SOLICITATION AMENDMENT

Title - Sujet South Substation Switchgear Replace	
Solicitation No. - N° de l'invitation EZ108-162126/A	Amendment No. - N° modif. 007
Client Reference No. - N° de référence du client	Date 2016-03-21
GETS Reference No. - N° de référence de SEAG PW-\$PWY-026-7753	
File No. - N° de dossier PWY-5-38400 (026)	CCC No./N° CCC - FMS No./N° VME
Solicitation Closes - L'invitation prend fin at - à 02:00 PM on - le 2016-03-29	
Time Zone Fuseau horaire Pacific Daylight Saving Time PDT	
F.O.B. - F.A.B. Plant-Usine: <input type="checkbox"/> Destination: <input checked="" type="checkbox"/> Other-Autre: <input type="checkbox"/>	
Address Enquiries to: - Adresser toutes questions à: Liu (PWY), Patty	Buyer Id - Id de l'acheteur pwy026
Telephone No. - N° de téléphone (604) 775-6227 ()	FAX No. - N° de FAX (604) 775-6633
Destination - of Goods, Services, and Construction: Destination - des biens, services et construction: PWGSC - Esquimalt Graving Dock - Victoria, BC

Amendment 007 has been raised to incorporate Addendum no. 3.

Project title/Titre du projet
ESQUIMALT GRAVING DOCK
SOUTH SUBSTATION SWITCHGEAR REPLACEMENT PROJECT
825 ADMIRALS ROAD, VICTORIA, B.C., V9A 2P1

Sheet/Feuille
SK-04

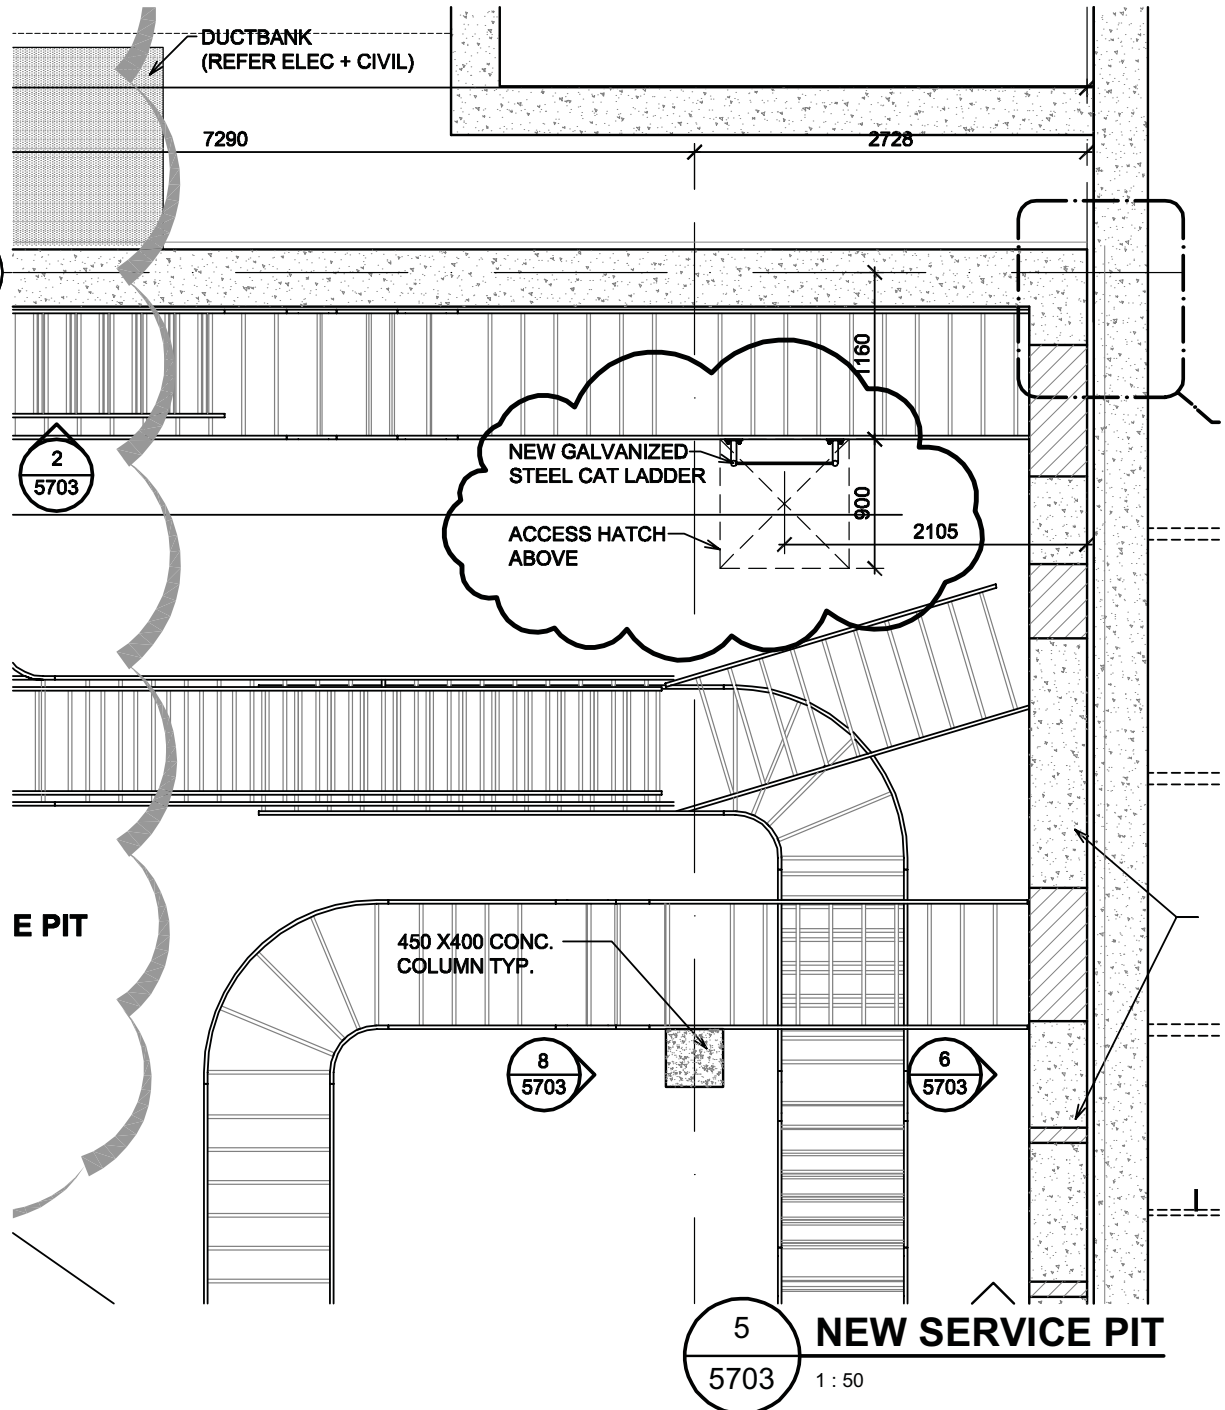
3. Refer to 2/5704 New Ground Floor Plan, Drawing 5704 - Main Floor Plan
Add access hatch per attached Drawing SK-04
4. Refer to Drawing 5704 - Main Floor Plan
Add detail 4/5704 Access Hatch Section per attached Drawing SK-06

Sheet/Feuille
SK-05

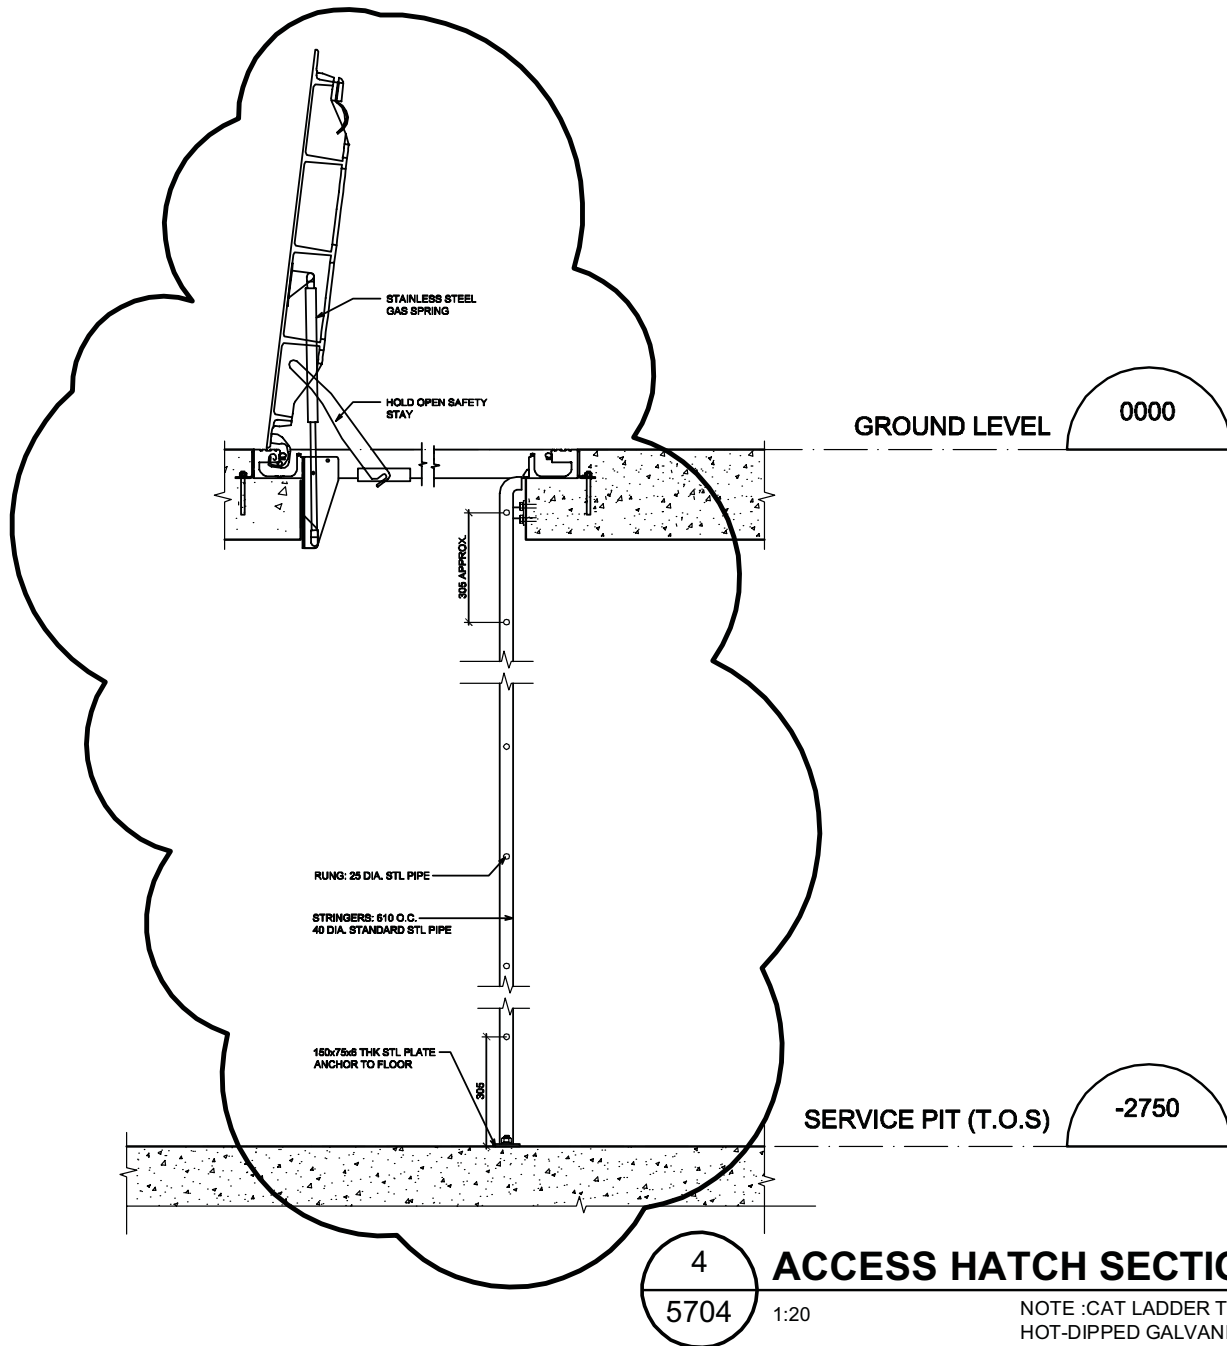
1. Refer to Wall Type Schedule, Drawing 5700 - Project Data
Revise Interior Wall Type Schedule, W1 and add Wall Type EW4 as per attached Drawing SK-07
2. Refer to 5/5703 New Service Pit, Drawing 5703 – Service Pit Plan
Add access hatch location and new steel cat ladder per attached Drawing SK-05

Sheet/Feuille
SK-07

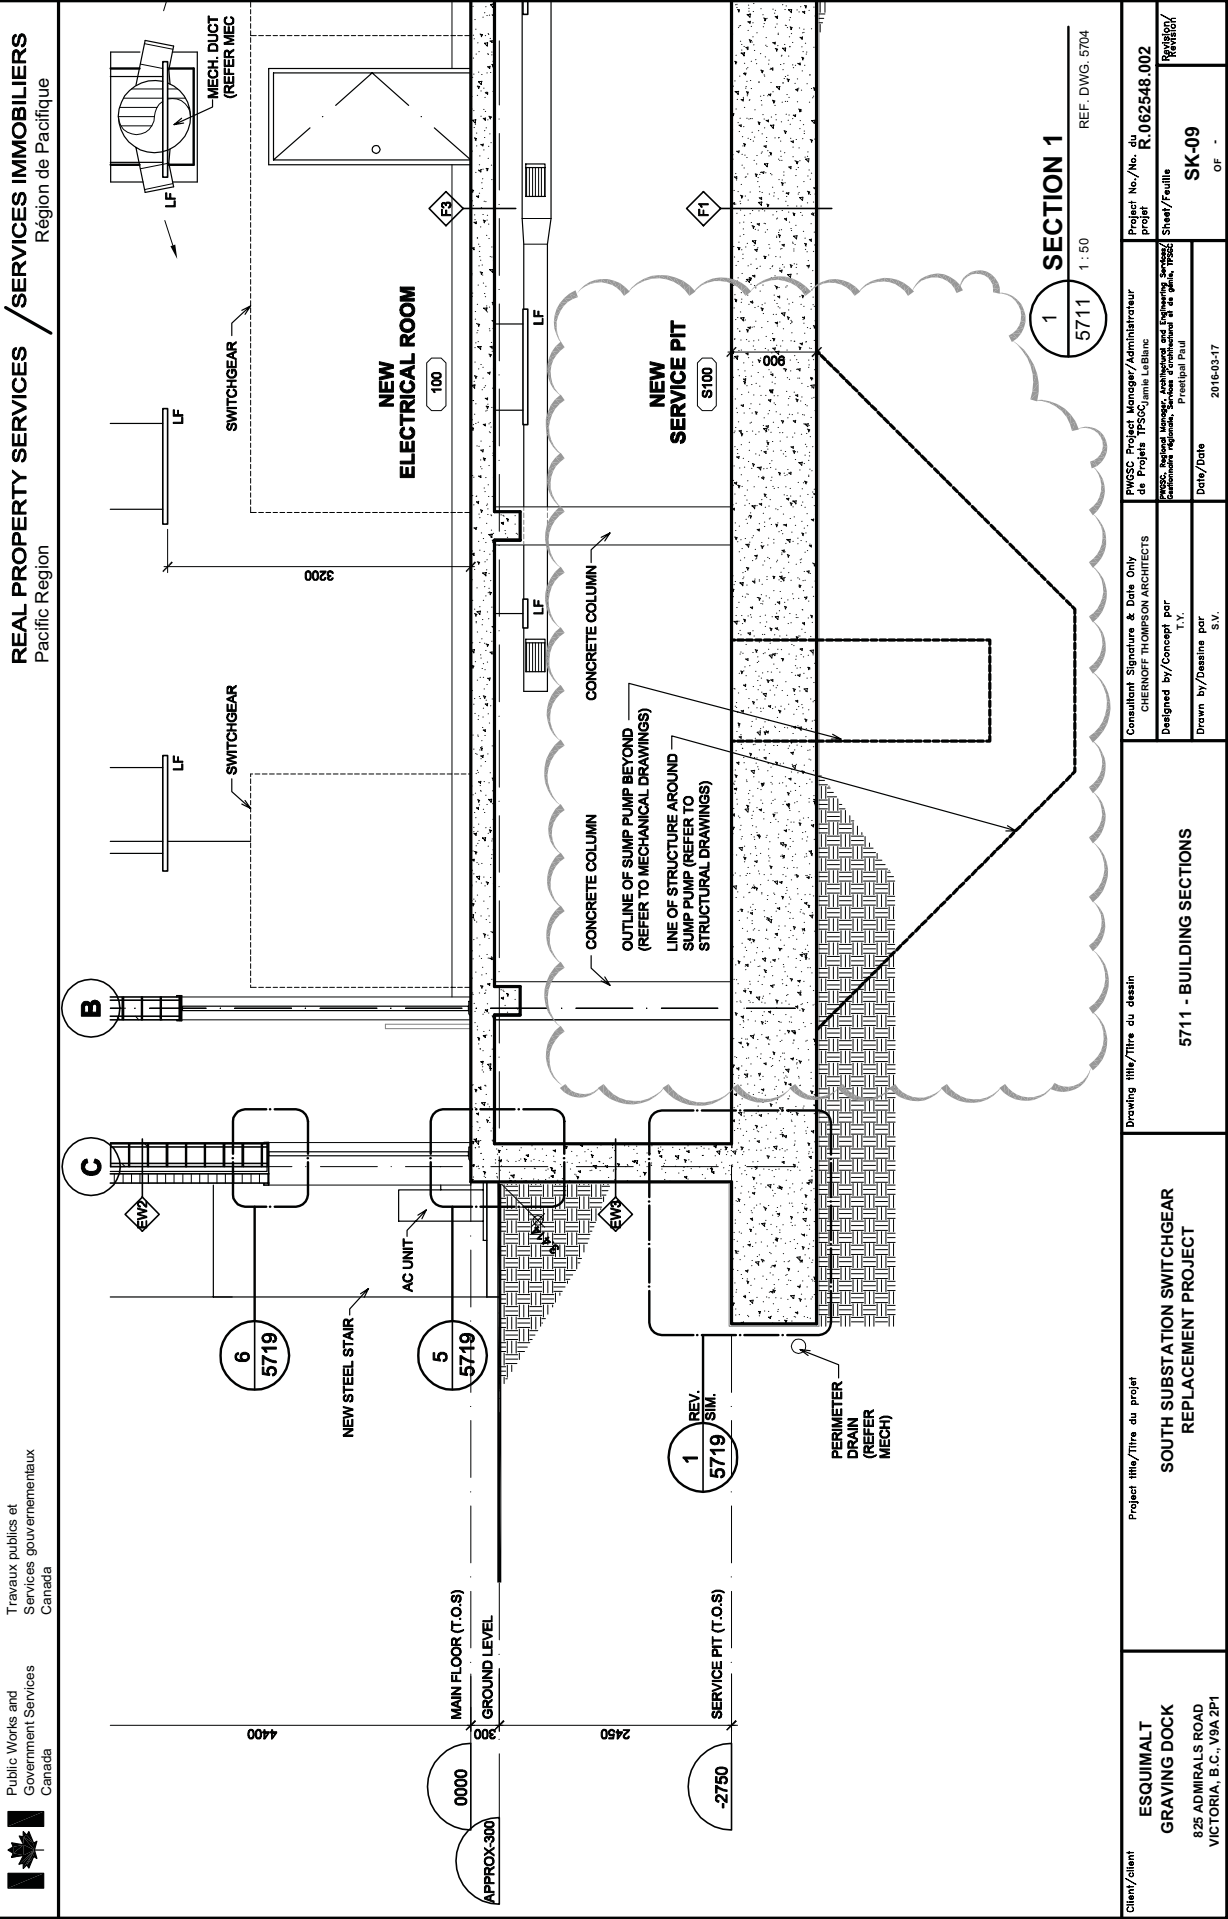
1. We note that on the Architectural drawings wall type W1 is called up as being 190mm thick concrete block however on the structural drawings these walls are noted as 240mm thick concrete block. Please confirm what thickness these walls are to be.

Response: Refer to attached drawing SK-07

TYP. INTERIOR WALL
- 240mm THK CONCRETE MASONRY BLOCK (PAINTED)
- REFER TO STRUCTURAL DRAWINGS FOR REINFORCEMENT AND GROUTING REQUIREMENTS

**TYPICAL BELOW GRADE
1 SEISMIC JOINT DETAIL**

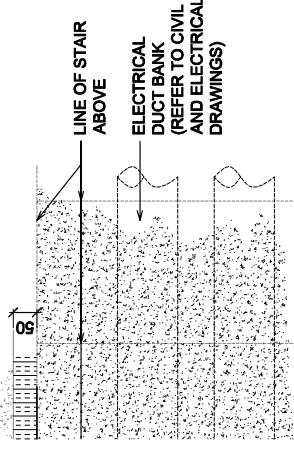
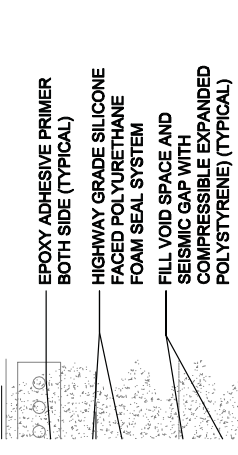
10. Refer to 1/5718 Typical Below Grade Seismic Joint Detail
 Clarify waterproofing extent per attached Drawing SK-13

Sheet/Feuille
SK-12
OF -

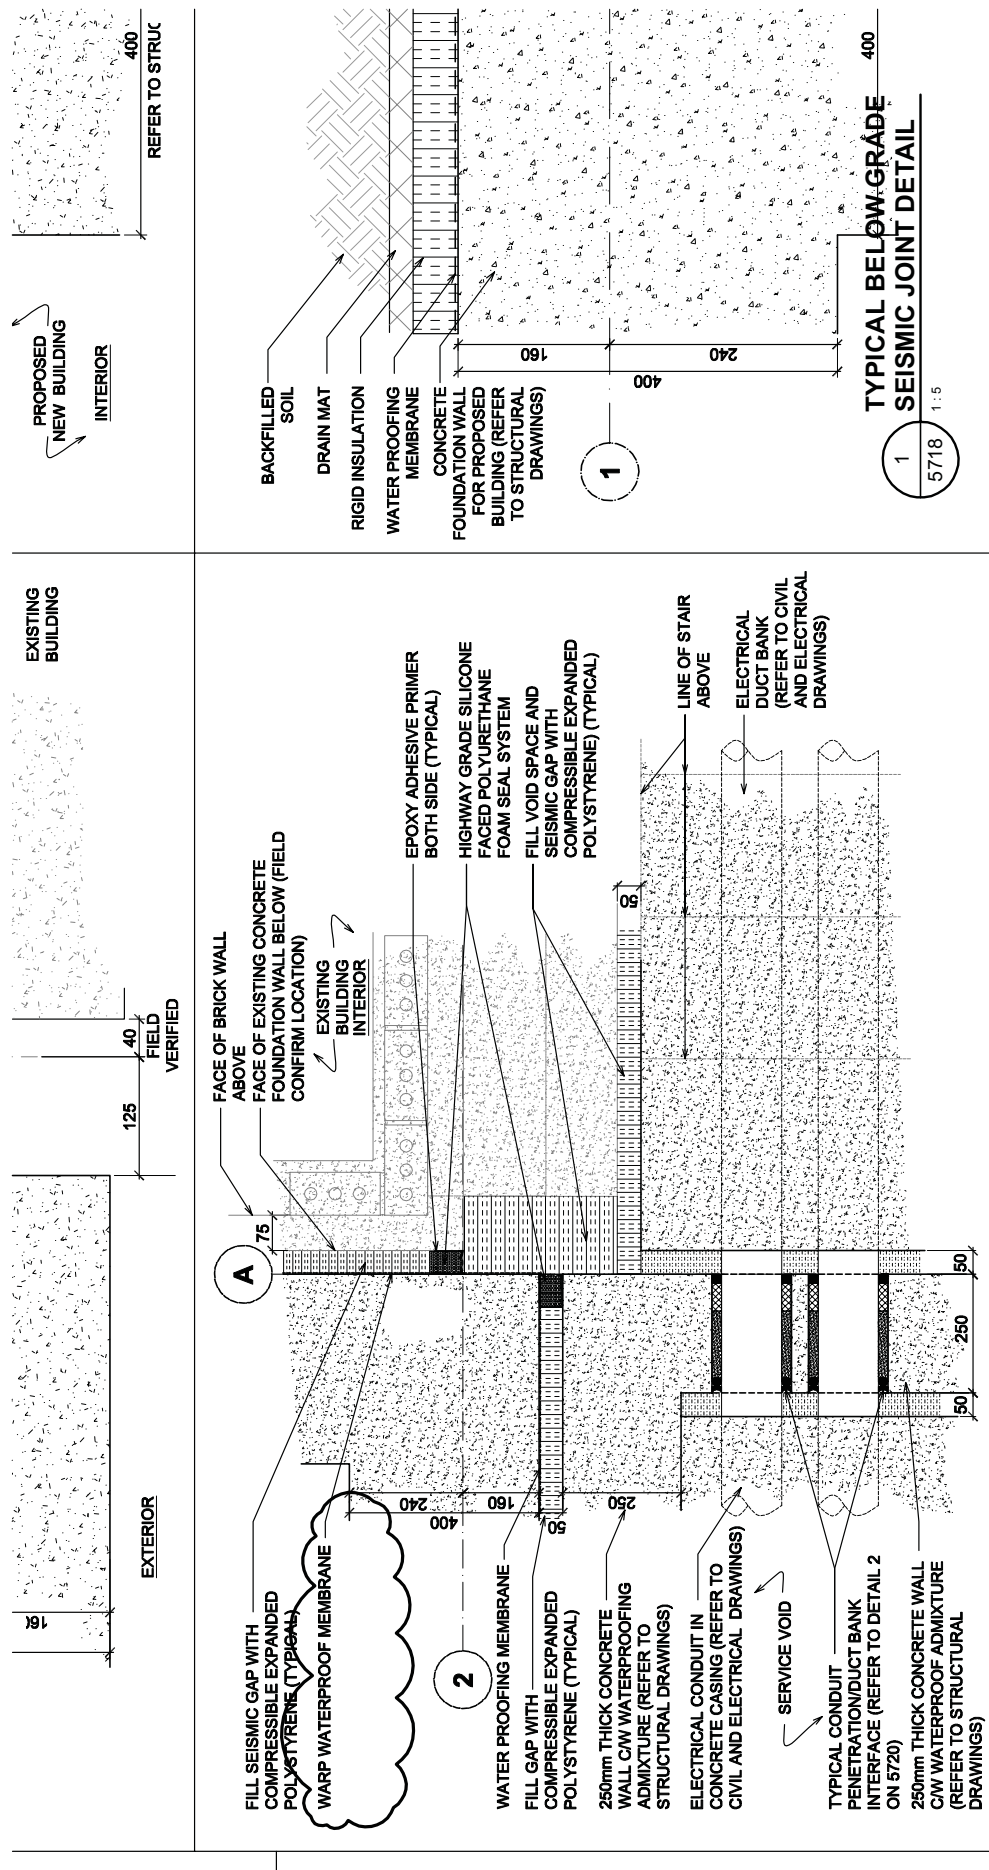
9. Refer to 5/5718 Duct Bank plan detail at gridline A-2
Clarify waterproofing extent per attached SK-12

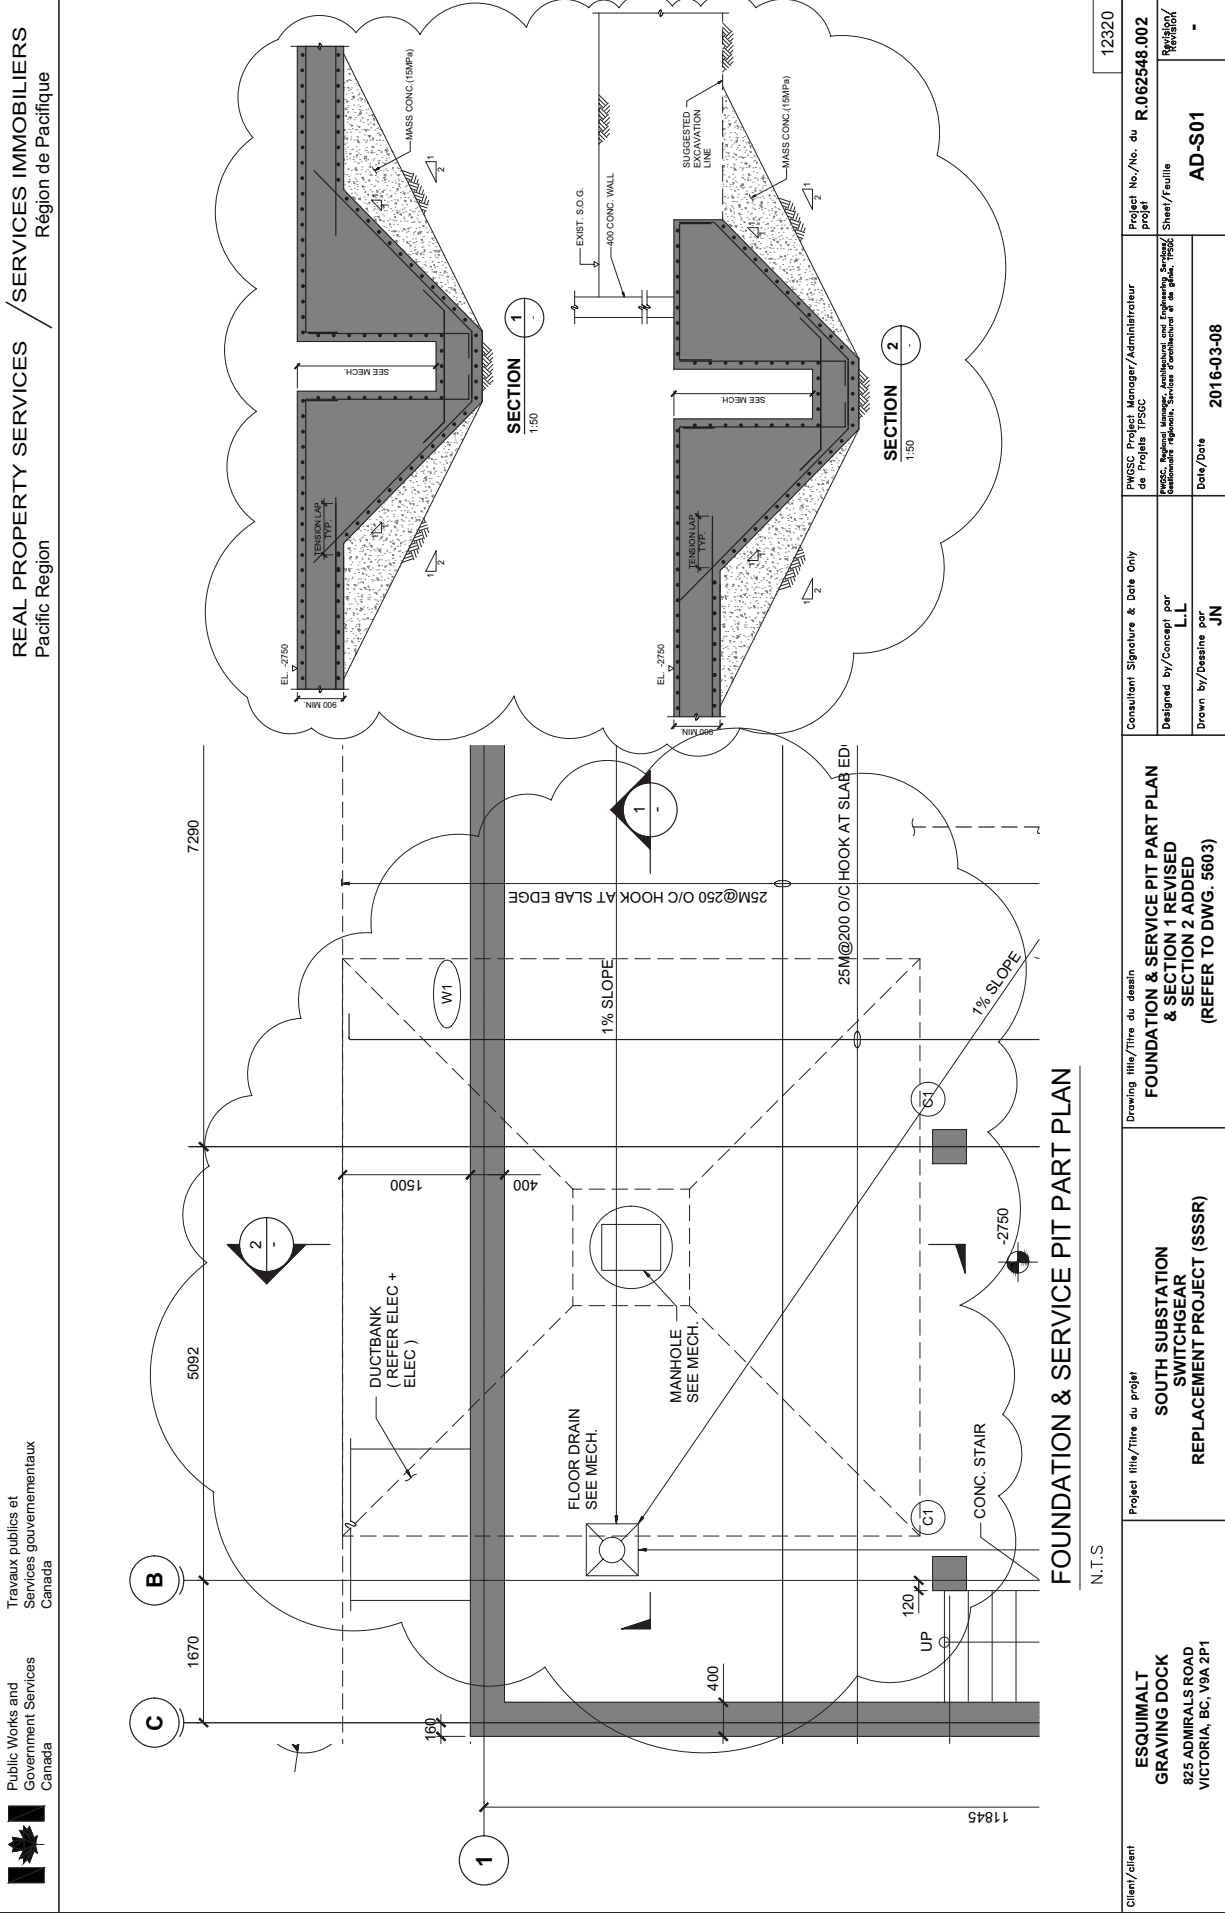
- QUESTION:** Please review the design of the Storm drainage system indicated on drawing 5805, particularly the need for the Subsoil Drain Lift Sump to be installed inside the Basement / Service Pit Floor. The Section through the Subsoil Drain Lift Sump, indicated on drawing 5806, requires the sump invert to be 2.725m below finish floor elevation. This significantly impacts the raft slab depression shown in section 1 / 5603 of the Structural drawings, which in turn impacts the overall dimensions of the raft slab. As it stands right now, Structural drawing 5603 does not correctly represent the impact of this Lift Sump. A quick calculation of the additional concrete volume due to this Lift Sump is in the order of 200 cm, plus the additional reinforcing steel.

- RESPONSE:** Revise section 1/5603 as per sketch AD-S01.
